State of Alaska
Department of Fish and Game
Sportfish Division

Nomination Form
Anadromous Waters Catalog

Anadromous Waters Catalog Number of Waterway 106-44-10010

Name of Waterway Hammer Slough USGS Name Local Name
 Addition Deletion Correction Backup Information

Figure 3.—106-44-10010 route correction map.

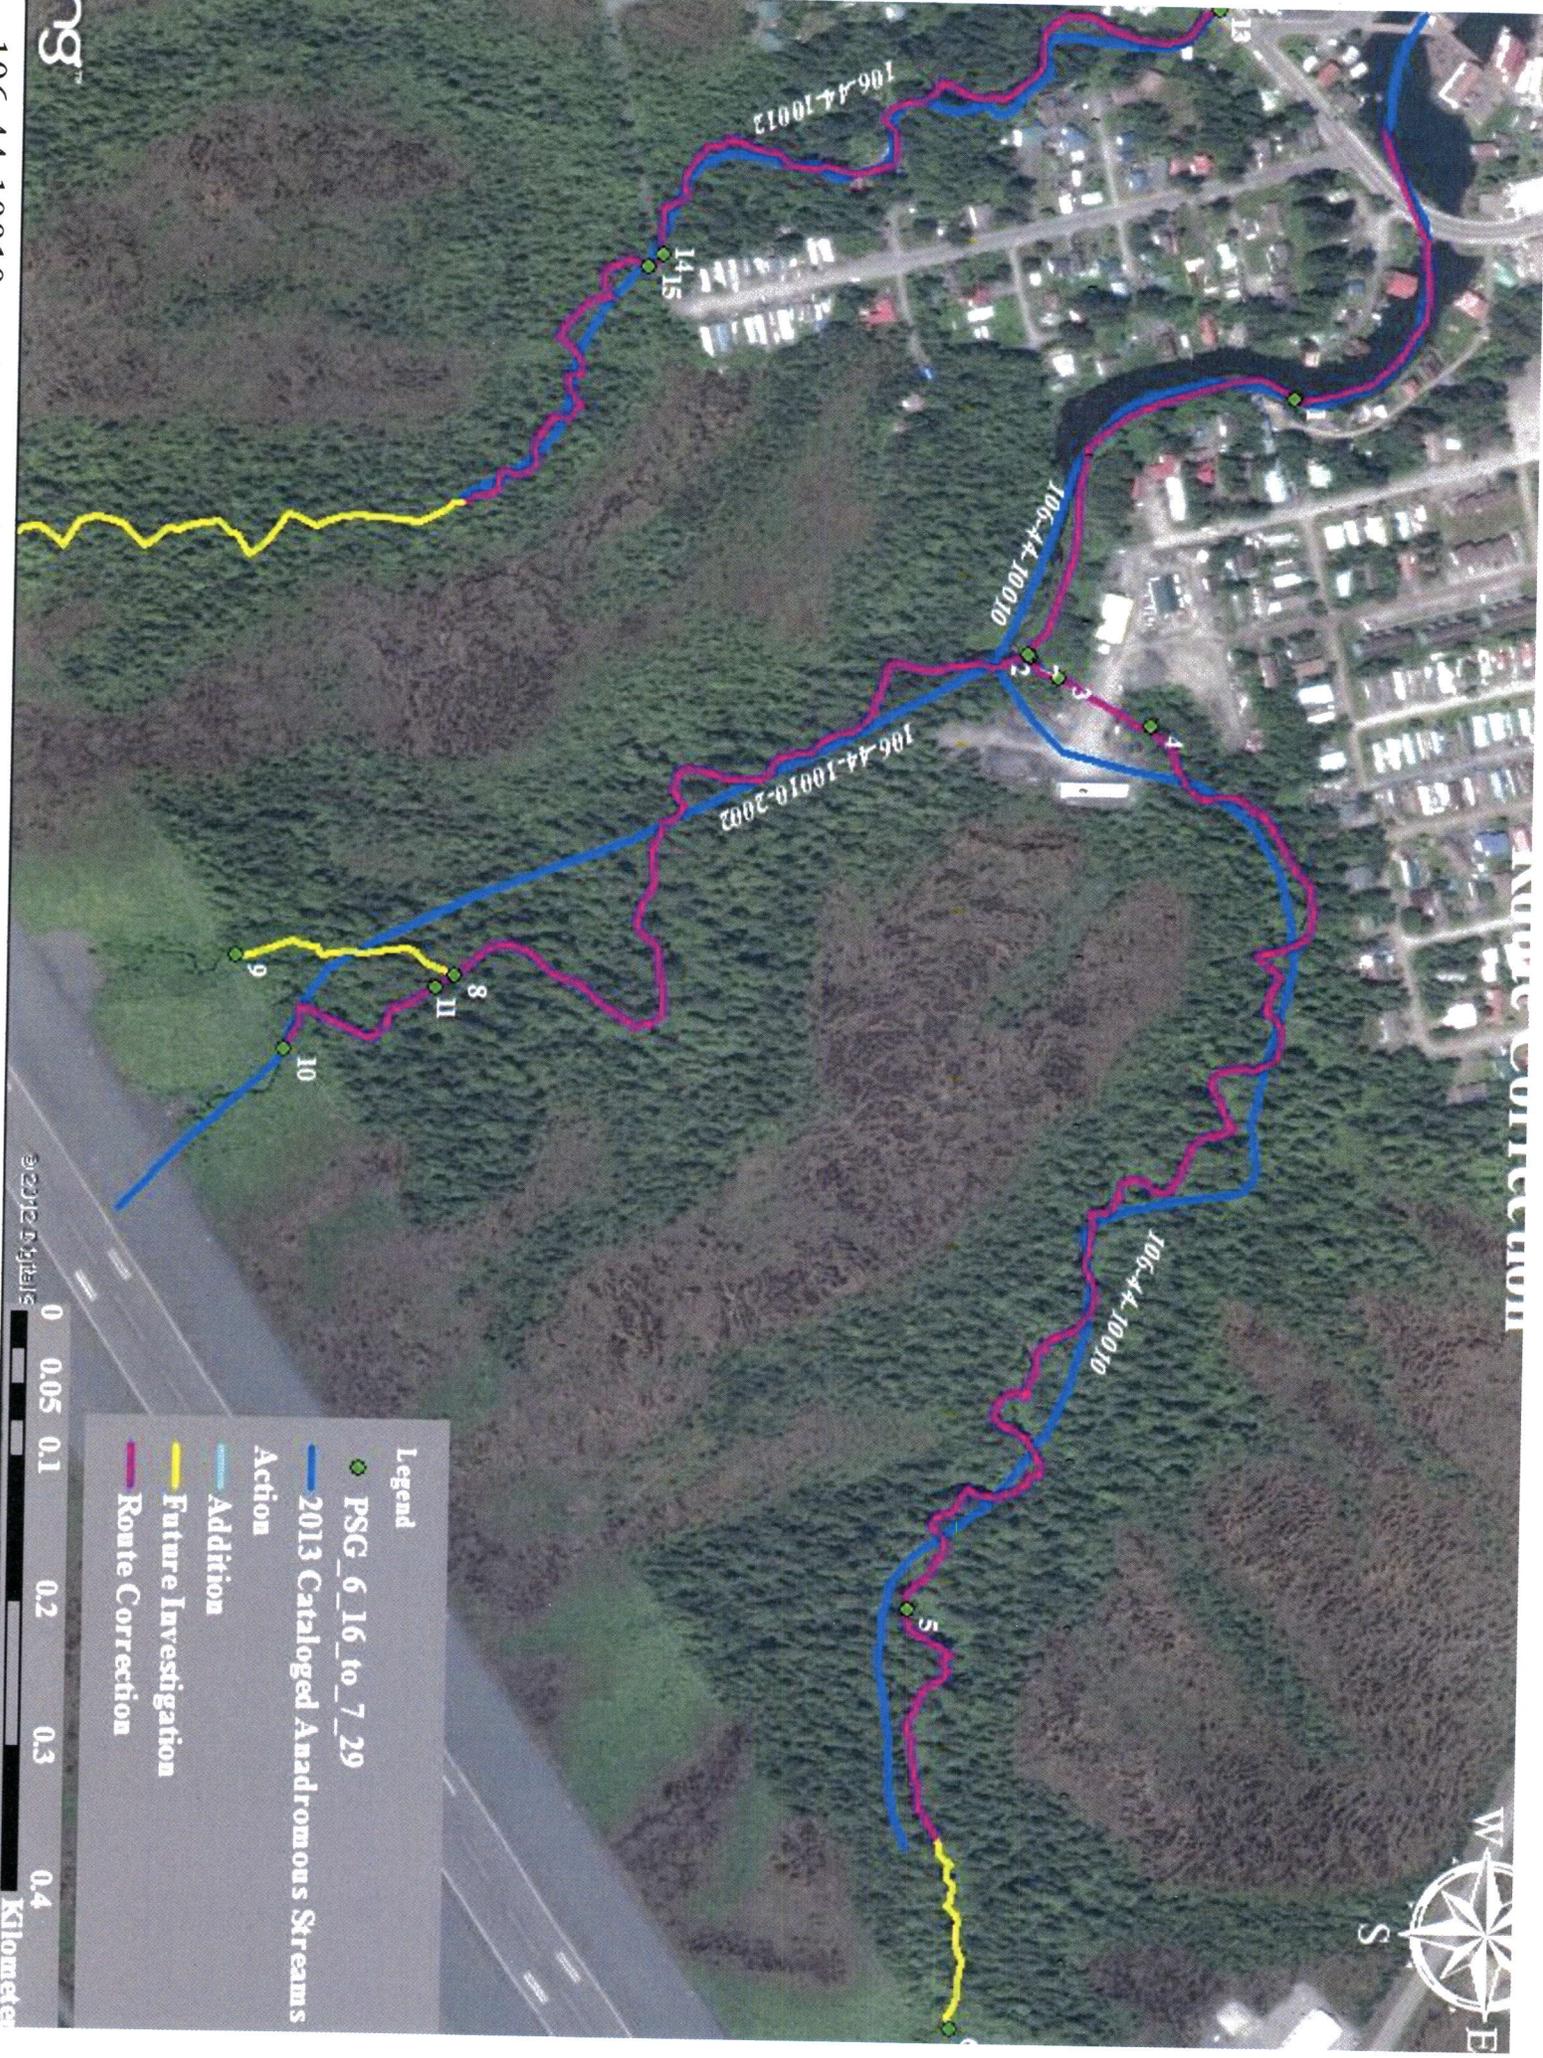
Update hydrography and reposition upper pt

106-44-10010**CORRECTION****Water body name:** Hammer Slough**Survey date:** 7/2/2013**Water body number:** 106-44-10010**Species & Lifestage:** Cop, Ps, DVp**Watershed:** Petersburg Creek-Frontal Wrangell Narrows**MTR:** C058S079E **Quad:** Petersburg D-3**Findings:** We tracked this stream with a GPS and found the route differs from what is documented in the Anadromous Waters Catalog (AWC).**Recommendations:** Update the route for 106-44-10010 in the AWC.

update hydro for 106-44-10010 & reposition upper pt;
use \noms\legere\Petersburg_Streams_2014_NL\Petersburg_Streams_2014_NL.shp for hydro
